**Application No:** 3175/24

**Location:** Mansion House, Dawson Street, Dublin 2

PROJECT:  
**Universal Access and  
 Landscaping Works at The  
 Mansion House, Dublin 2**  
 CLIENT:  
 DUBLIN CITY COUNCIL CITY ARCHITECTS DIV.

Title:  
**STRUCTURAL SECTIONS**

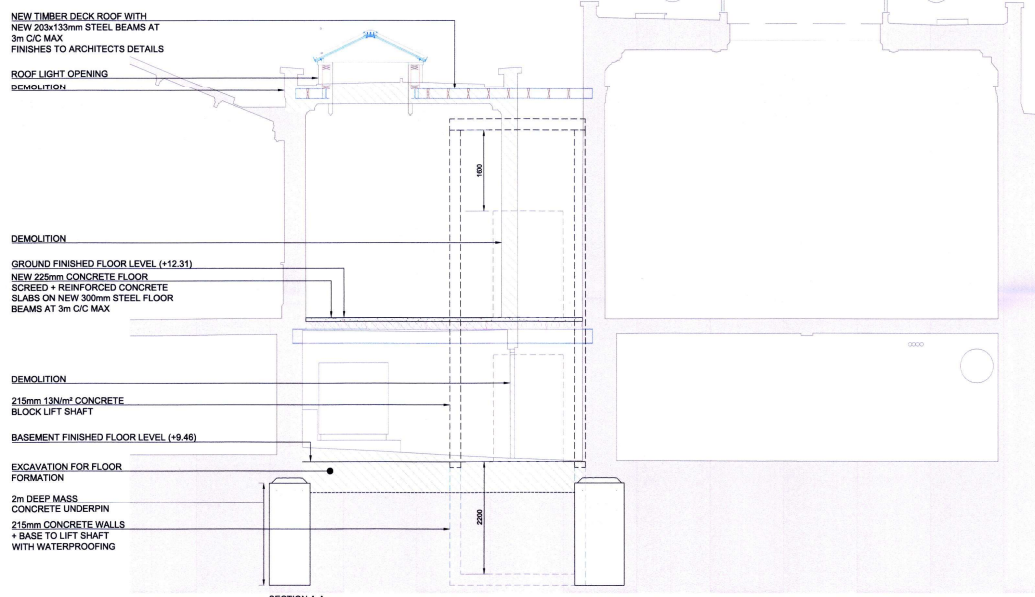
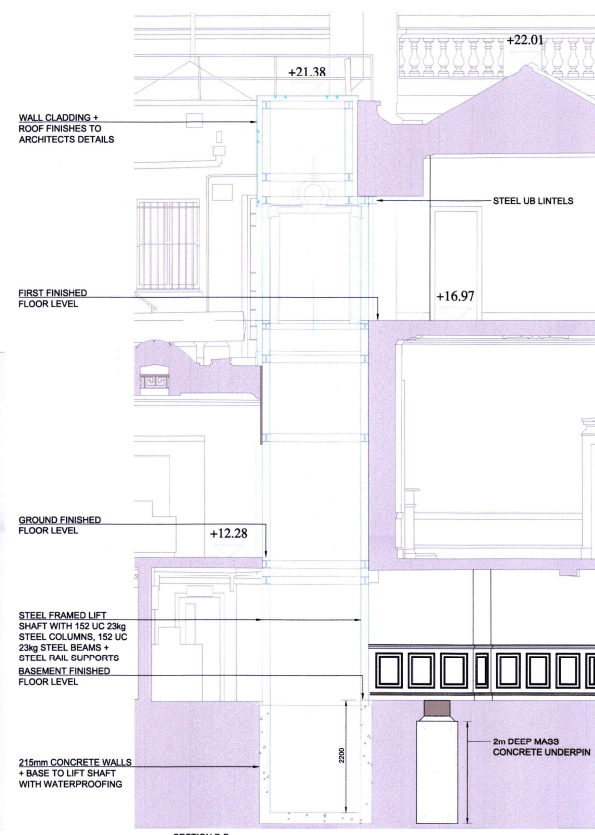
*There is underpinning proposed to all structural walls surrounding the proposed new lifts. While it is recognised that the proposed lift within the Mansion House is to be located in an ancillary basement space, and that the proposed lift leading to the Round Room would be in a less significant space than the Mansion House itself, the CO recommends that the lifts to be installed are without lift pit.*

i. The applicant shall provide further detail of the structural design proposal around the two proposed lift shafts.
